#### Addendum 63: Regulation No. 64

#### Amendment 3

### UNIFORM PROVISIONS CONCERNING THE APPROVAL OF VEHICLES EQUIPPED WITH TEMPORARY-USE SPARE WHEELS/TYRES

Paragraph 5.1.4.1., amend to read (the diagram is not amended):

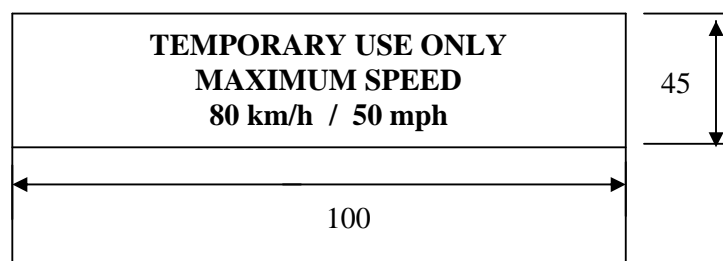
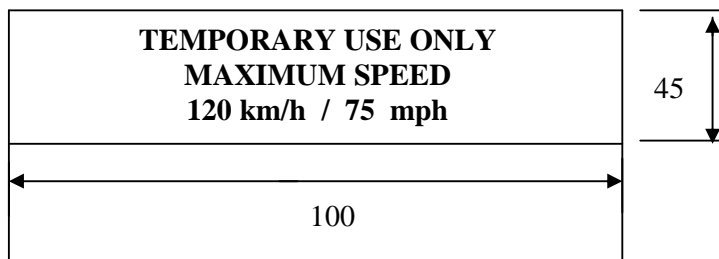
"5.1.4.1. An 80 km/h maximum speed warning symbol arranged in accordance with the diagram below shall be permanently displayed on the outer face of the wheel in a prominent position.

In the case of vehicles intended to be sold in countries using imperial units of measurement, an additional warning symbol, identical to that described above, with the exception that the figure "80" shall be replaced by "50" and the wording "km/h" by "mph", shall be permanently displayed on the outer face of the wheel in a prominent position.

Alternatively a single warning symbol arranged in accordance with the diagram below, shall be permanently displayed on the outer face of the wheel in a prominent position.

Upper case letters shall be at least 5 mm high and the numbers "80" and "50" shall be at least 20 mm high with the elements that make up each character of the number at least 3 mm line thickness. Lower case text shall at least have a line height of 5 mm. All text shall be enclosed in a border and be on a background of contrasting colour.

The requirements of this paragraph shall only apply to types 1, 2 and 3 temporary use spare unit as defined in paragraphs 2.10.1., 2.10.2. and 2.10.3."

Annex 2, correct to read:

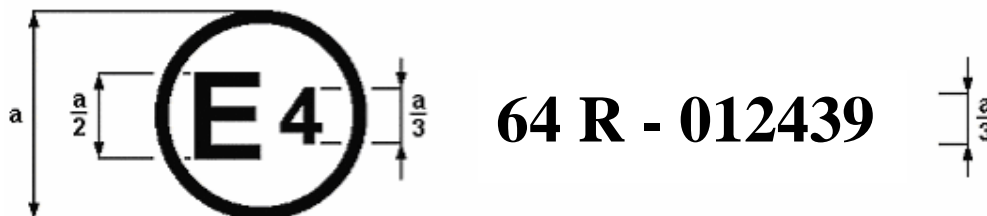
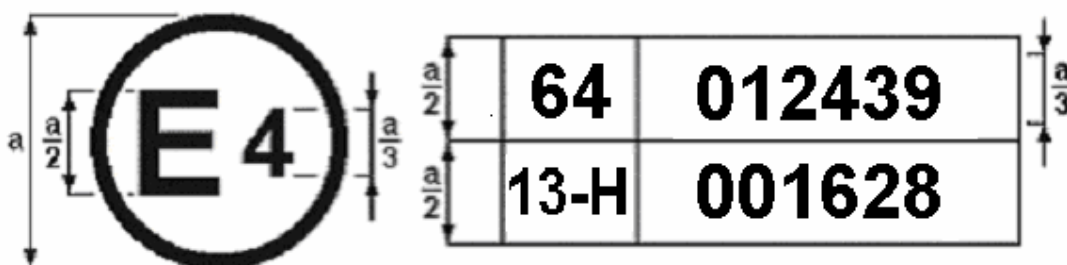
Model A

a = 8 mm min.

The above approval mark affixed to a vehicle shows that the vehicle type concerned has, with regard to the equipment of temporary-use spare unit(s), been approved in the Netherlands (E 4), pursuant to Regulation No. 64 under approval number 012439. The approval number indicates that the approval was granted in accordance with the requirements of Regulation No. 64, incorporating the 01 series of amendments.

Model B

(See paragraph 4.5. of this Regulation)

a = 8 mm min.

The above approval mark affixed to a vehicle shows that the vehicle type concerned has been approved in the Netherlands (E 4) pursuant to Regulations Nos. 64 and 13-H. 1/ The approval numbers indicate that, at the dates when the respective approvals were given, Regulation No. 64 included the 01 series of amendments and Regulation No. 13-H was in its original form.
